R 35/36-01D 4819 Dorset Avenue  
(Somerset Historic District)

PRELIMINARY CONSULTATION

New Accessory Building  
 4819 Dorset Avenue, Somerset Heights  
 Montgomery County, Maryland

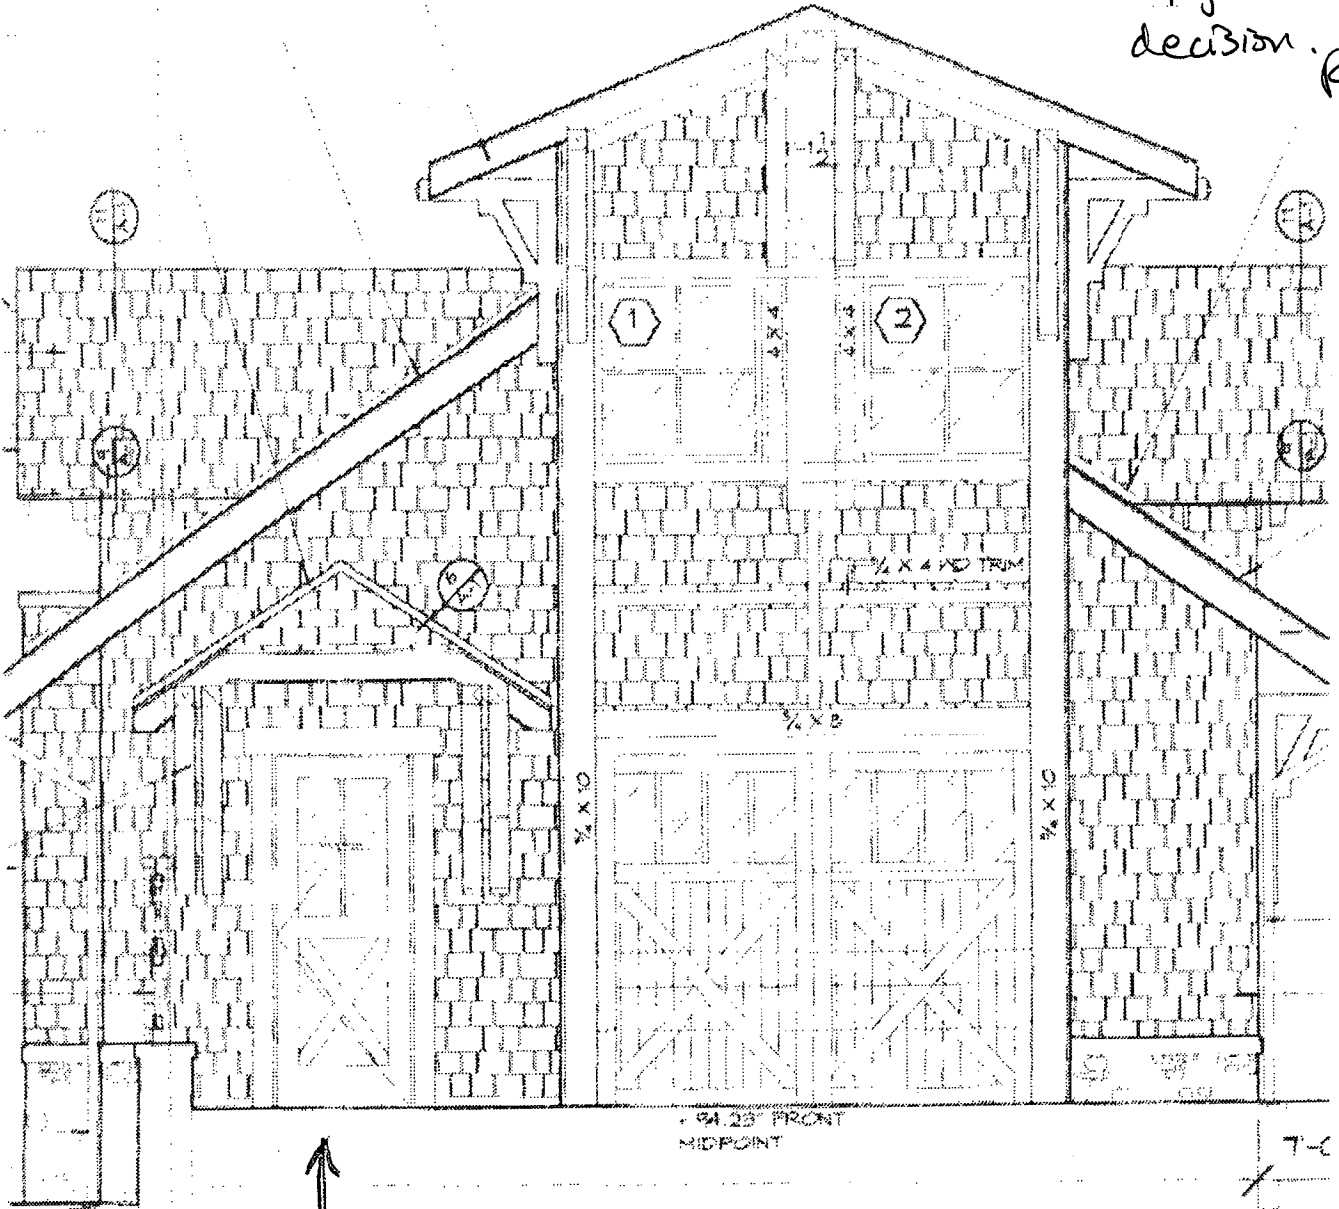
This dwg. revised to show 1 door with 1/2" door is 3'0" wide swing door

Robins: this is the proposed door (actually with a 3x3 divided lights). It is proposed to be 3'x8' instead of the original 3'10"x8'. Also, to right is proposed overhead door (same size, design slightly altered) - Bardon Rubenstein

Revised drawing of single door + overhead door in keeping with HPC decision. RDZ.

# 1 WALL SECTION

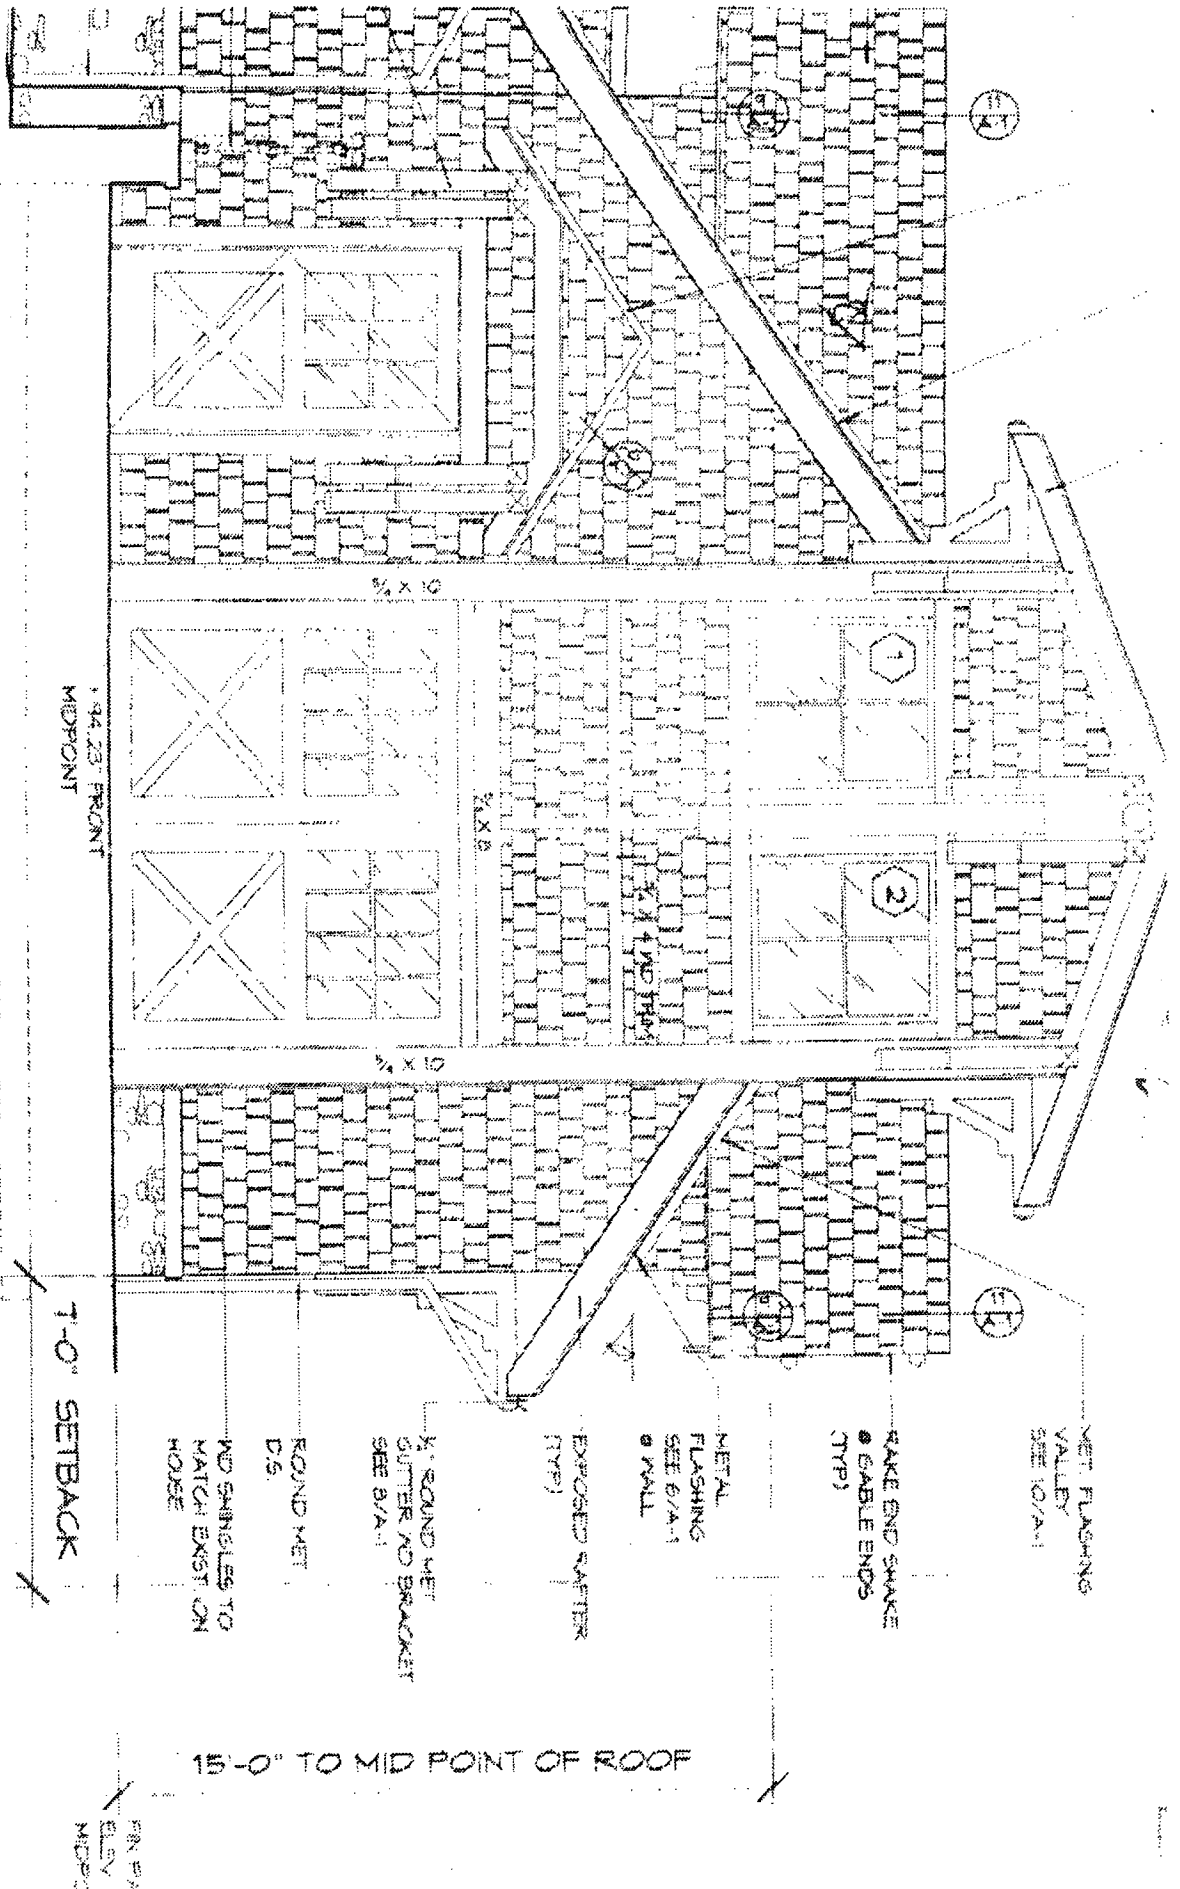
*Robin: The proposed change would use a 1 1/2"-2" flagstone instead of the fieldstone specified here. This wall does not face Dorset Ave.*  
*- Brent Ruben*

# 2 S. STUDIO EXTERIOR ELEV.

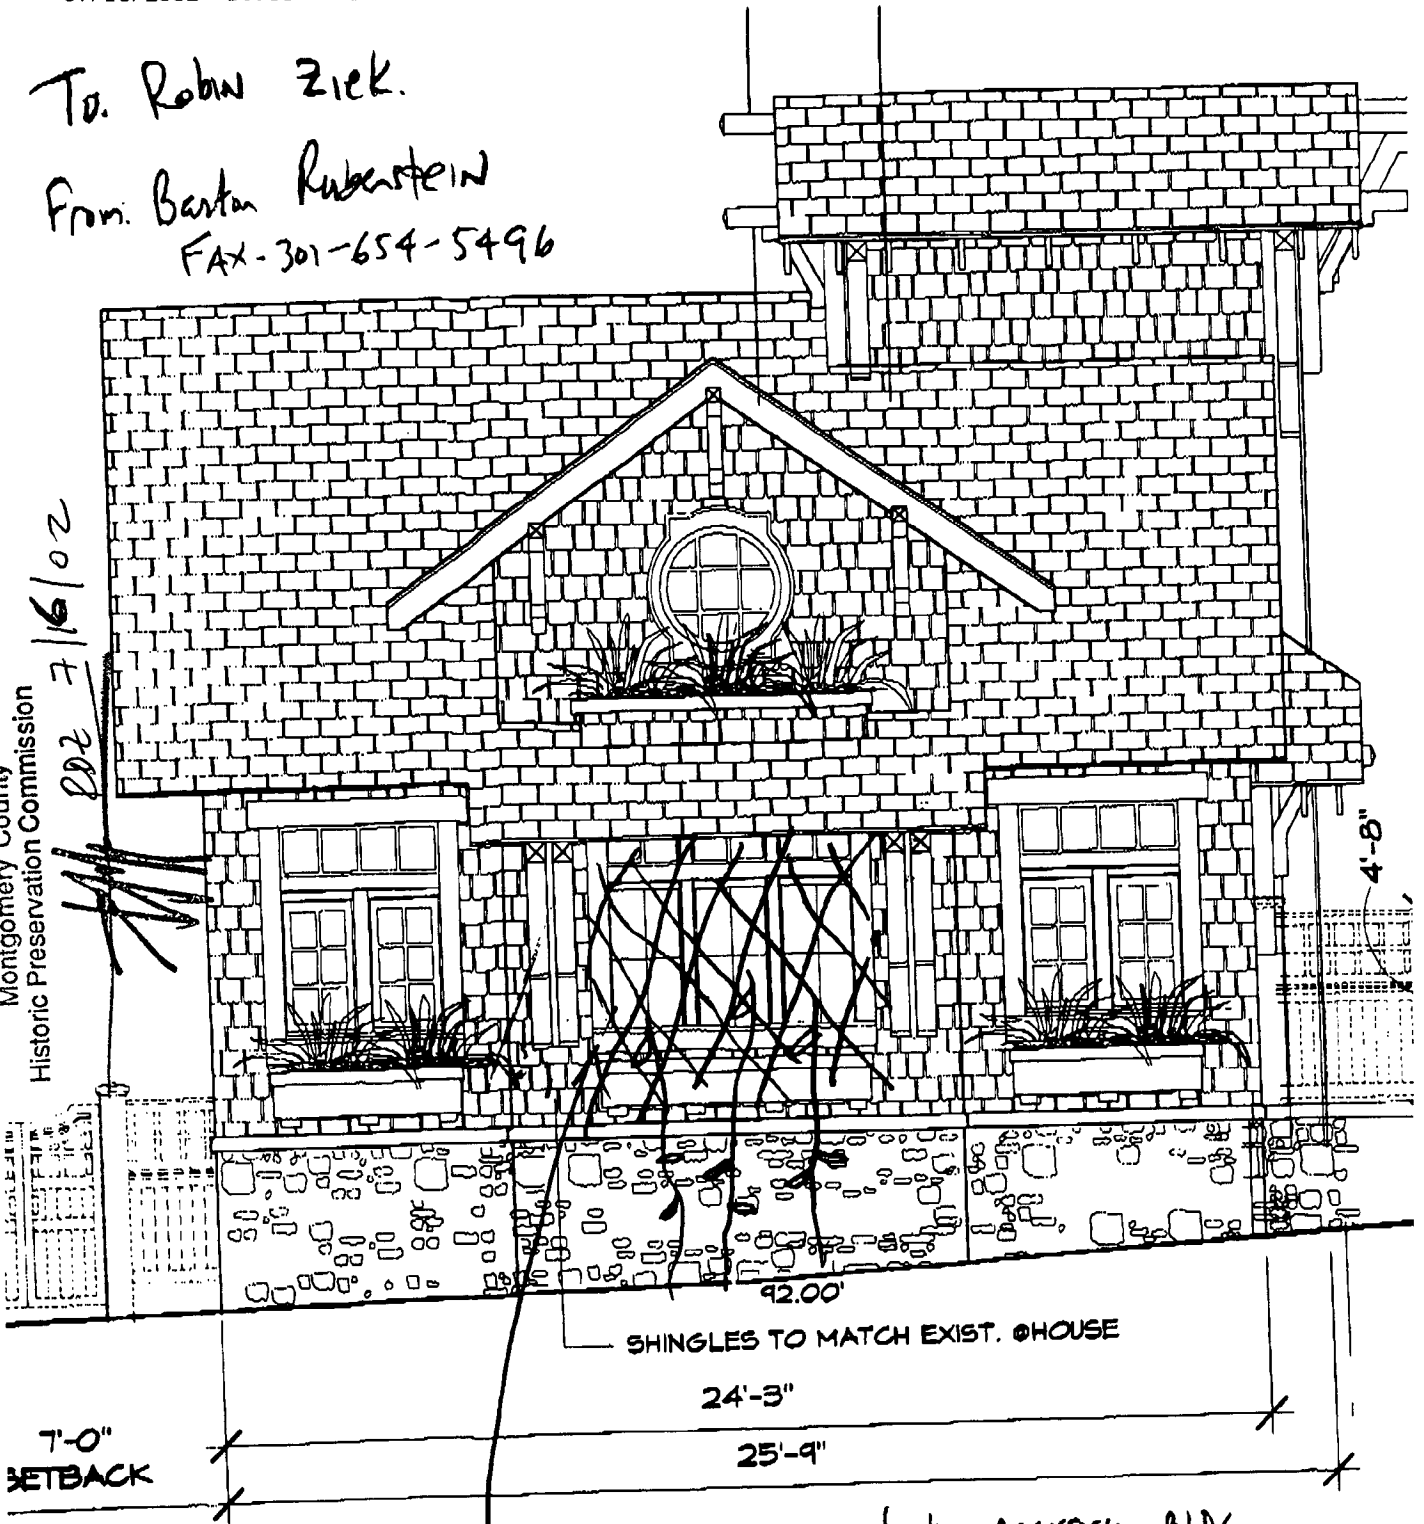
Robin: This is the originally submitted design, faxed to you so that you can compare with other submitted. *Correct*

\*This elevation faces Sweet Alley, but is excluded by the historic garage. *Bar-Rubenstein*

*Done as approved by*

### 3 W. ACCESSORY BLDG. EXT. ELEV.

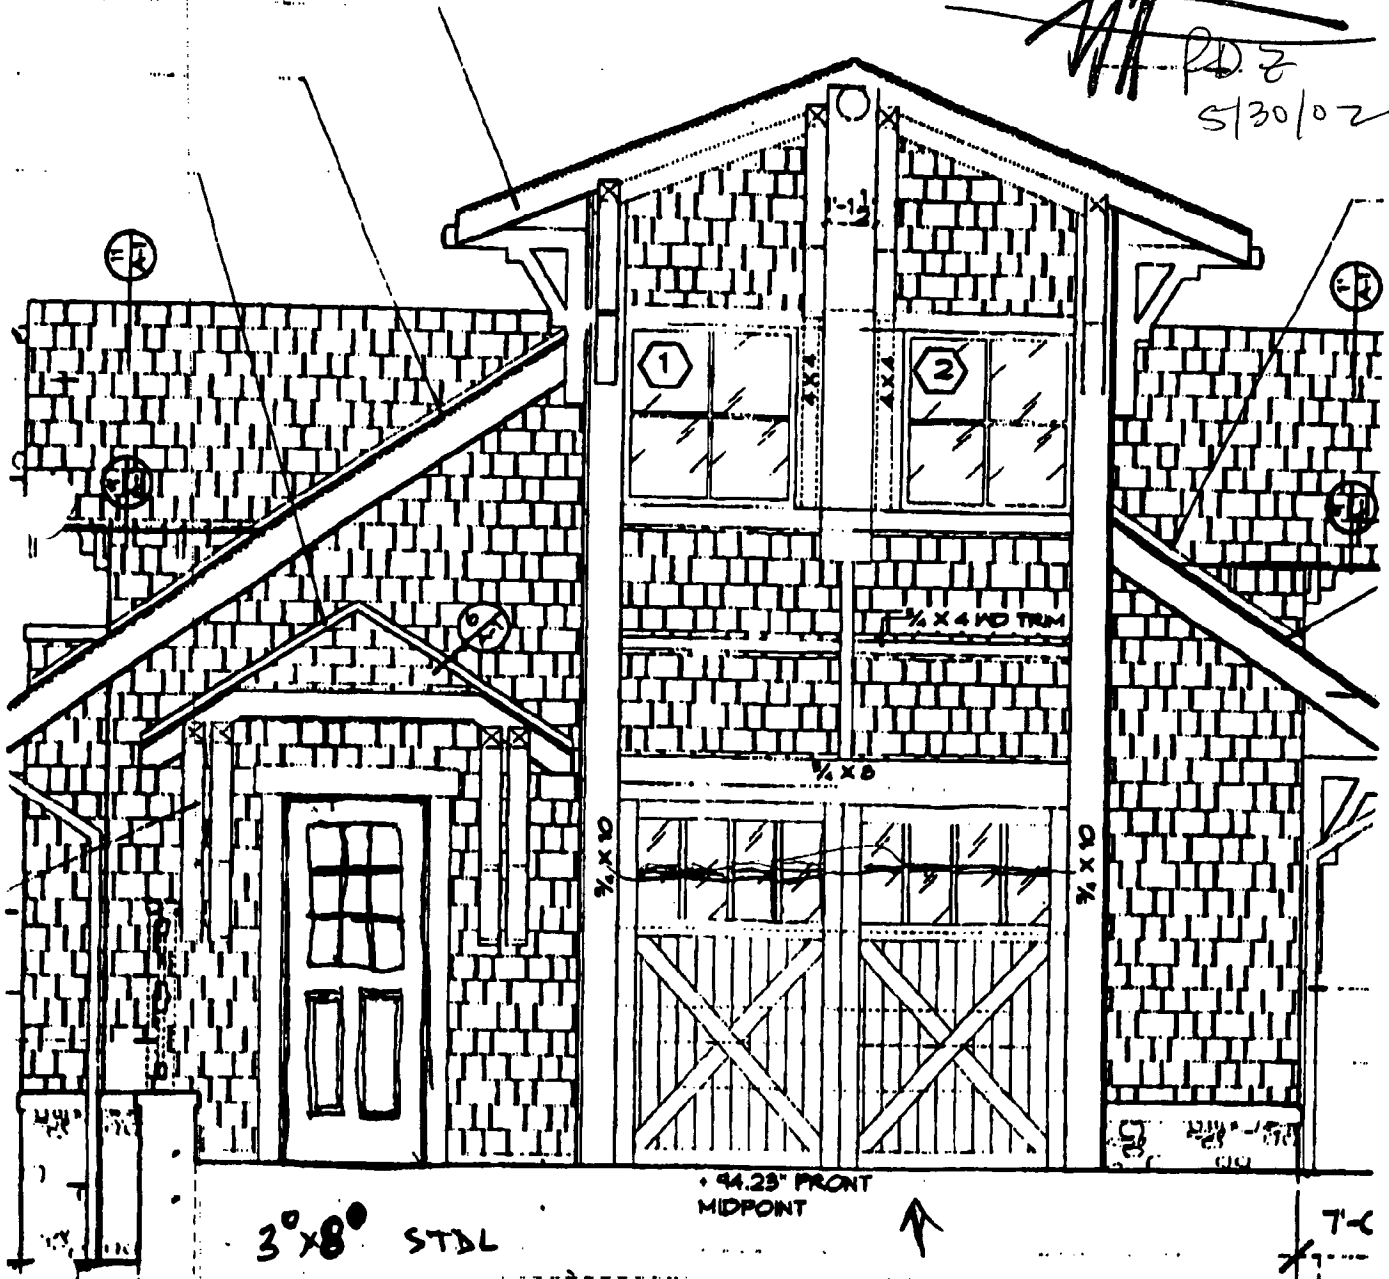
Robin, this side of the Accessory Bldg  
 Does not face Dorset Ave, it faces the side yard, I am wondering  
 if it is ok to remove the window and let plants grow here, eg wisteria.  
 Hope all is well,  
 Barton Rubenstein
